Subject: Response to Administratively Incomplete Determination Part A and General Part B of the Resource Conservation and Recovery Act (RCRA) Permit Renewal Application Los Alamos National Laboratory EPA ID#NM0890010515, HWB-LANL-20-001

**Response to Administratively Incomplete
Determination Part A and General Part B of the
RCRA Permit Renewal Application Los Alamos
National Laboratory EPA ID#NM0890010515,
HWB-LANL-20-001**

Maps of Groundwater Contamination Plumes at LANL

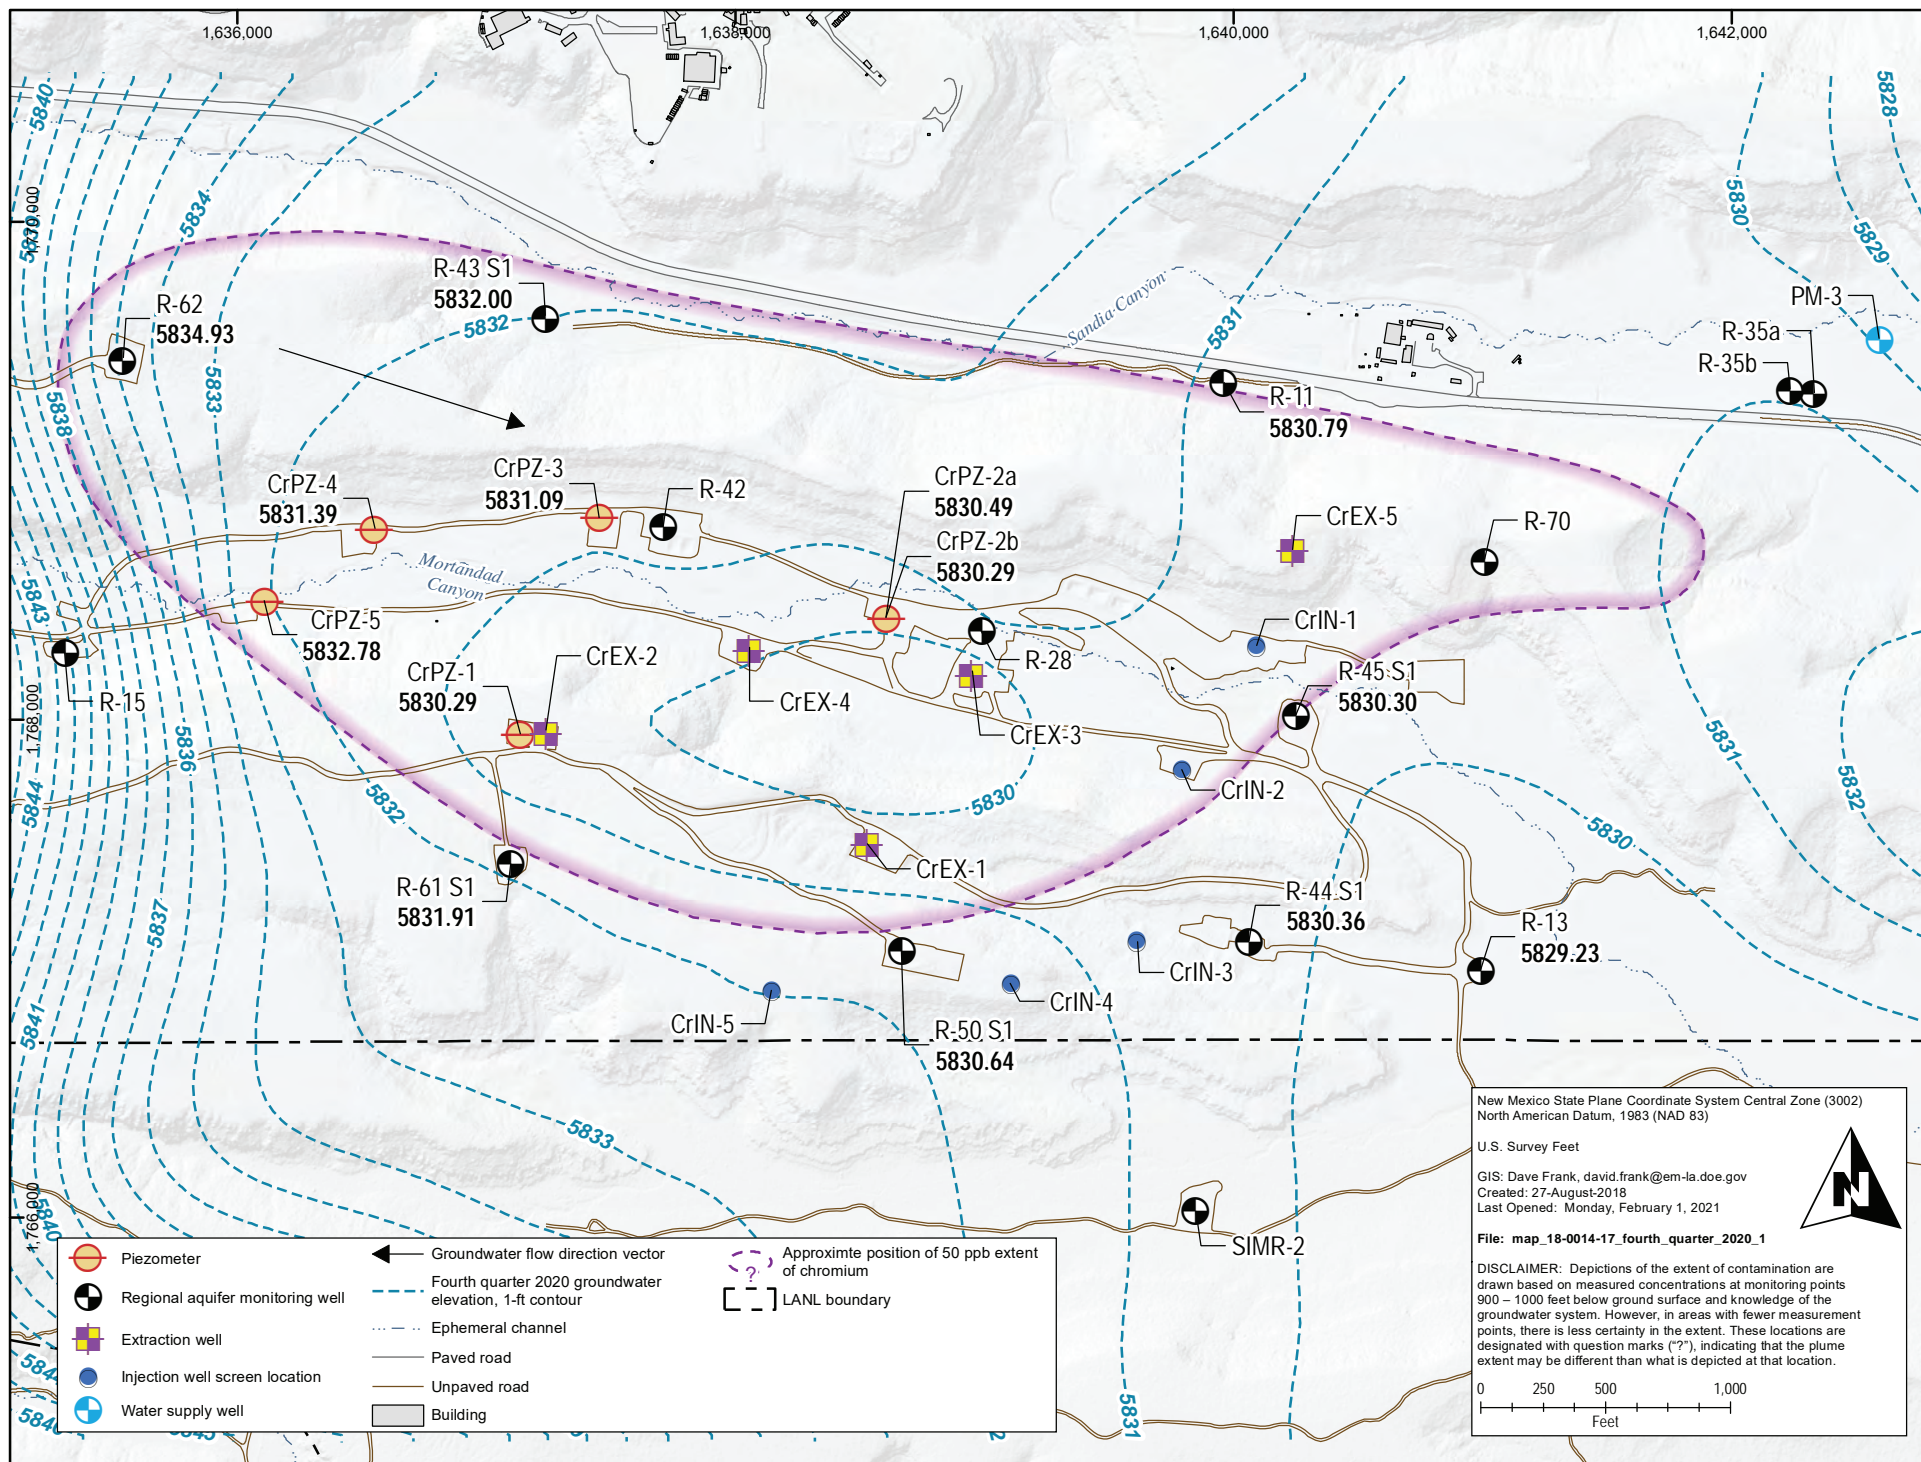
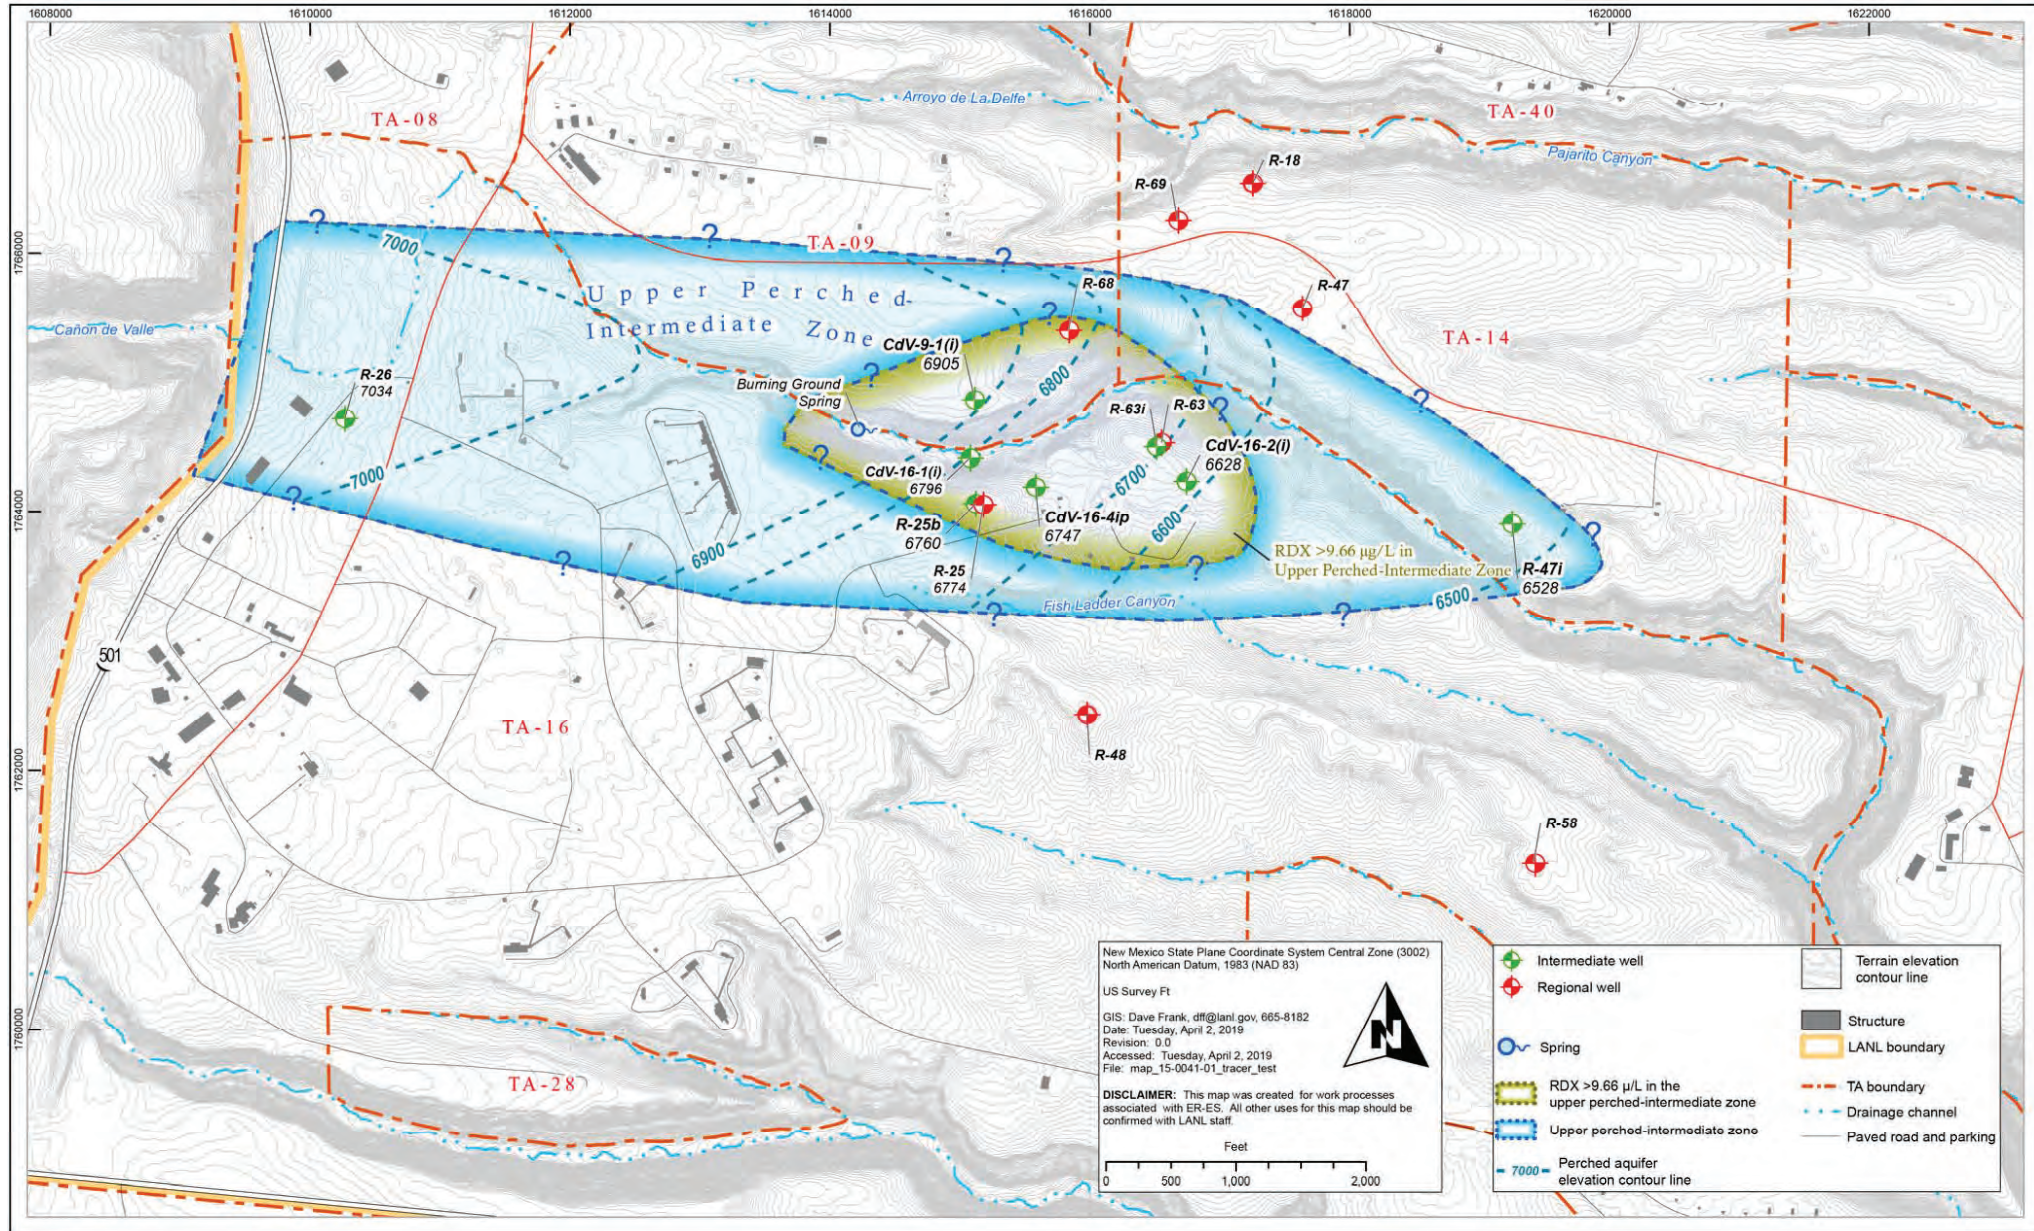
The United States Department of Energy (DOE), Newport Nuclear-BWXT (N3B), and Triad National Security, LLC. (Triad), collectively the Permittees, have not provided maps depicting the extent of the existing ground water plumes at the LANL Facility (Facility, as defined in 40 CFR 260.10) in accordance with the above requirements. Maps 2 and 3 show National Pollution Discharge Elimination System (NPDES) site locations and other groundwater monitoring wells, however, these maps do not provide contaminant plume boundaries. Include maps depicting extent of plumes and maximum concentration of contaminants on a topographic map as required by 40 CFR 270.14(b)(19).

There is no evidence of groundwater contamination associated with the regulated units at LANL; therefore, a map of groundwater contamination plumes is not included within the Permit and was not included within the Permit Renewal Application. As described in Permit Renewal Application Section 2.16, *Groundwater Monitoring*, groundwater at LANL is monitored under the 2016 Consent Order by the LANL Interim Facility-Wide Groundwater Monitoring Plan. There are no changes proposed to Permit Section 11.3.1, *Groundwater Monitoring* presented in the Permit Renewal Application Section 2.16. All known groundwater plumes are from SWMUs/AOCs, and are addressed under the Consent Order. As a courtesy, the most recent published plume maps for chromium and RDX are attached to this response (Attachment 2). These plume maps have already been provided in the *Quarterly Report for the Discharge of Treated Groundwater to the Regional Aquifer under Discharge Permit 1835, Calendar Year 2020 Quarter 4*, submitted to NMED-HWB February 26, 2021, and *Investigation Report for Royal Demolition Explosive in Deep Groundwater*, submitted to NMED-HWB on August 29, 2019, located in the N3B electronic reading room, <https://ext.em-la.doe.gov/epr/readingroom.aspx?room=2>. It should be noted that concentration/plume maps will change based upon data results.
